**MOUNTAIN REGIONAL WATER SPECIAL SERVICE DISTRICT
PARK CITY, UTAH**

SIGNAL HILL WATER TREATMENT PLANT OPTIMIZATION

ENGINEER PROJECT NO. 203230

**ADDENDUM NO. 3
TO THE
CONTRACT DOCUMENTS**

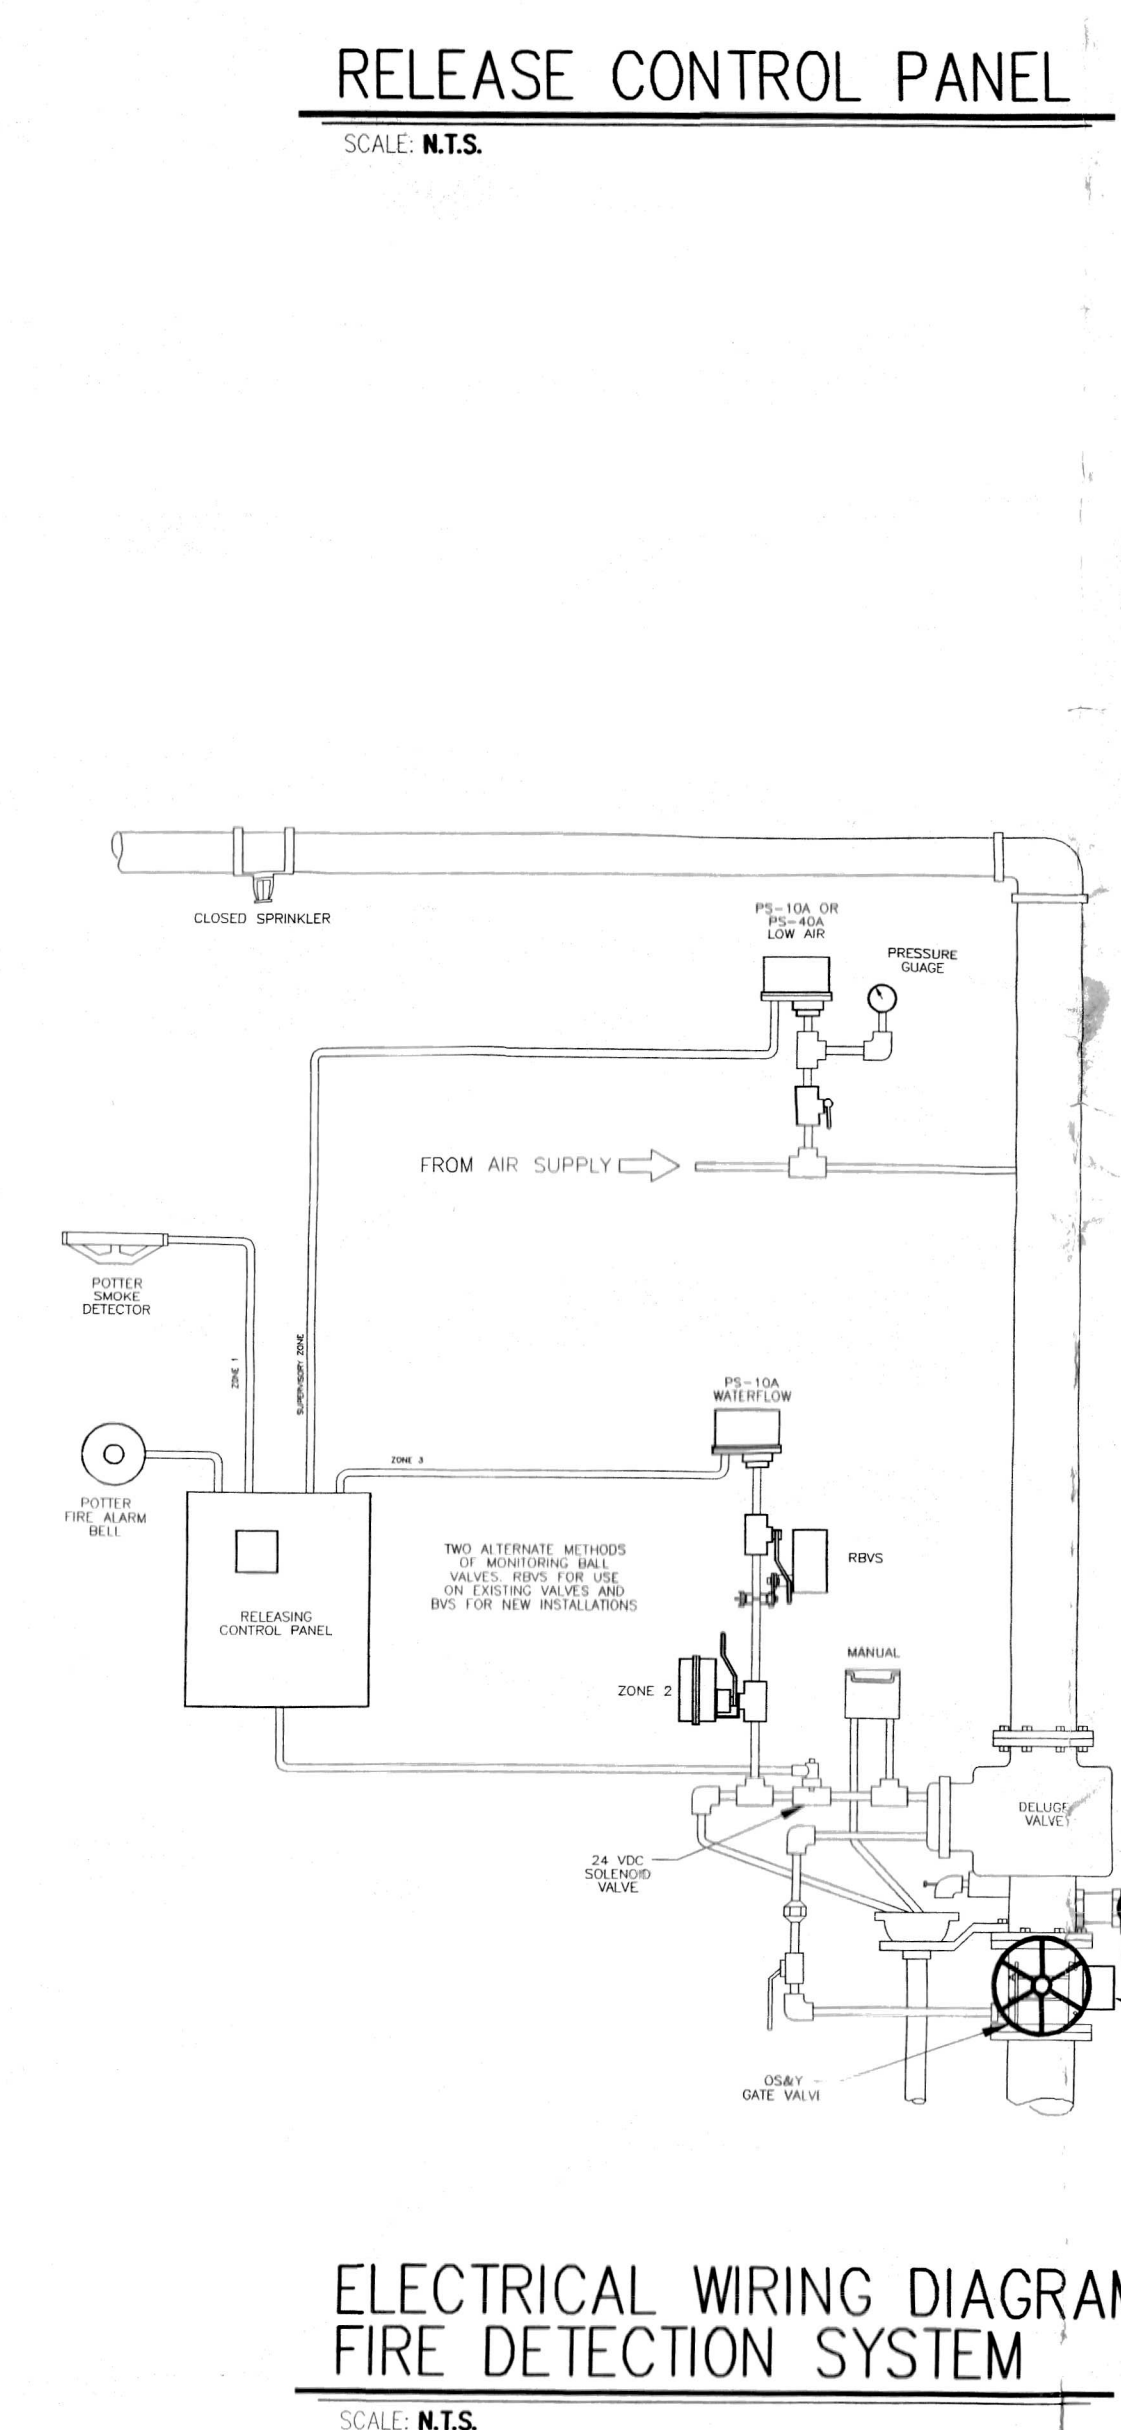
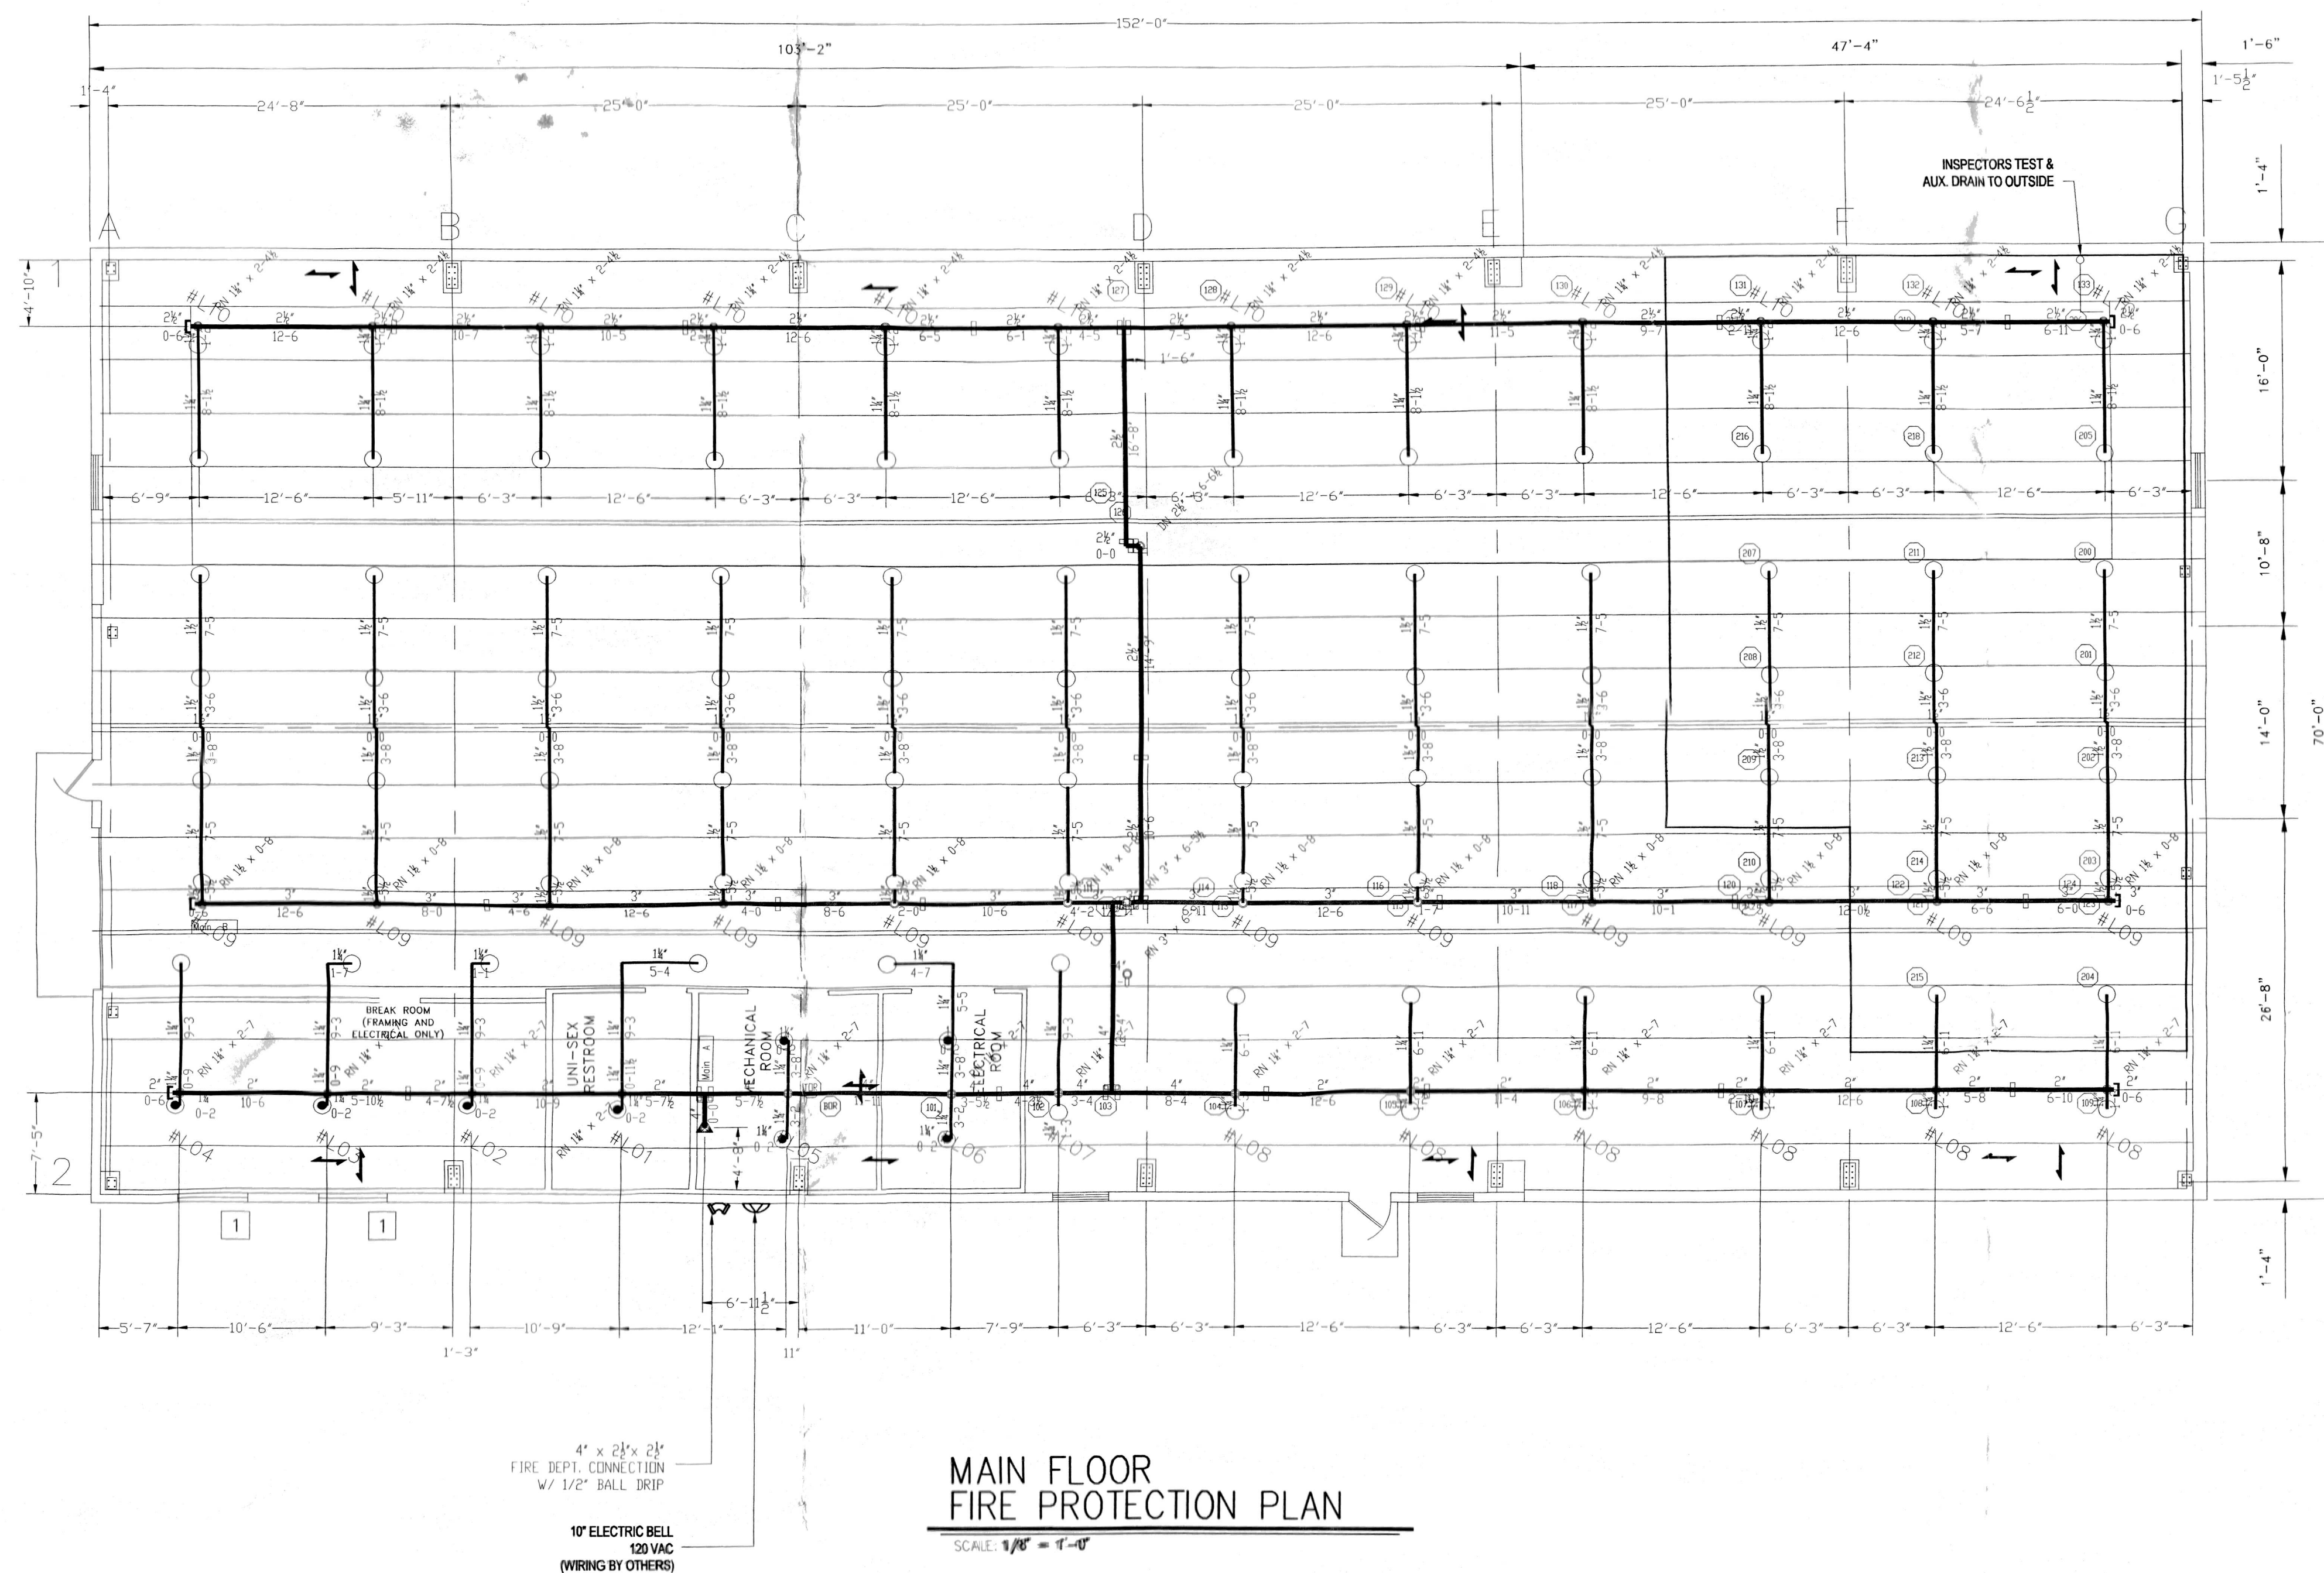
- 1. See attached drawings of the existing fire system.
- 2. See attached “Bidder Question Log” for bidder questions and Engineer responses.

Will new fire alarm systems be required for all three of these buildings, or will we need to tie into any existing fire alarm systems?	See 40F01 and 70F01. Also see Addendum No. 3 for supplemental information for the existing fire system.
Will the Electrical Engineer be adding drawings for fire alarm for these projects? We went through the drawings and there are no fire alarm drawings in the documents.	See Addendum No. 3 for supplemental information for the existing fire system.
